Preliminary Information

PIP5491 Intermittent service 4wd messages displayed in the DIC

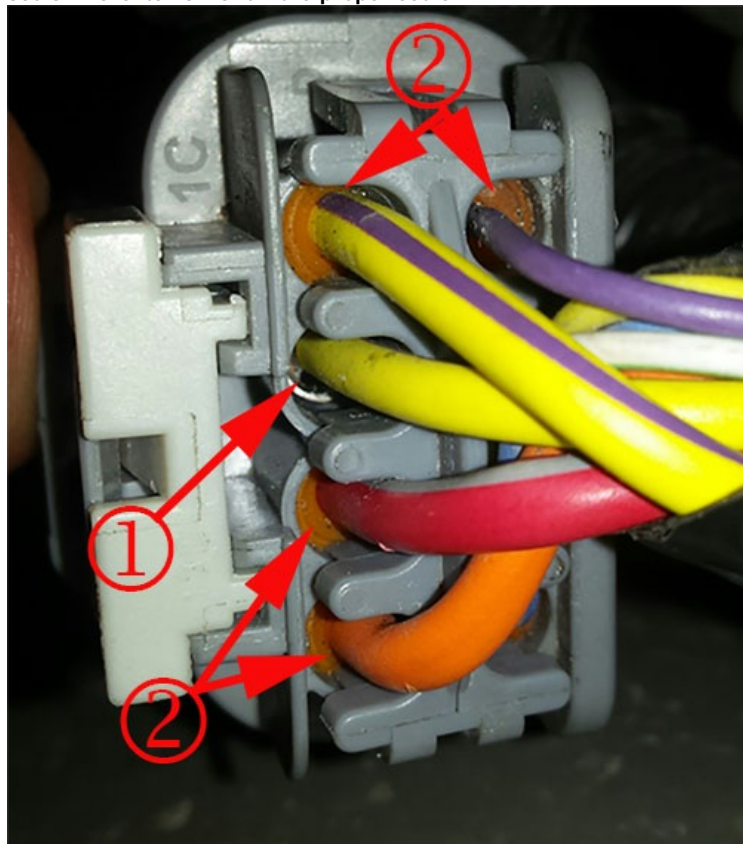
When diagnosing intermittent transfer case control module DTCs related to signal or circuit integrity including C0321, C0392, C0396, C0398, C0306, C039E, C038D inspect the related connectors and ensure that the seals are properly installed in the connectors. Missing seals allow moisture inside the connector and will cause repeat conditions and or different intermittent conditions. Items number 1 below show missing seals where items 2 show the proper seals.

Some connectors are serviced as a connector, some have terminated leads and some are available as harness only. If there is corrosion in the connector and has to be replaced, the mating side of the connector should also be replaced whether it is another connector or electrical component. Example if the connector at the transfer case actuator is replaced due to a missing seal and corrosion is present the transfer case actuator should also be replaced. In this instance use the appropriate labor operation for the wiring repair performed and if component replacement is required submit that as net amount.
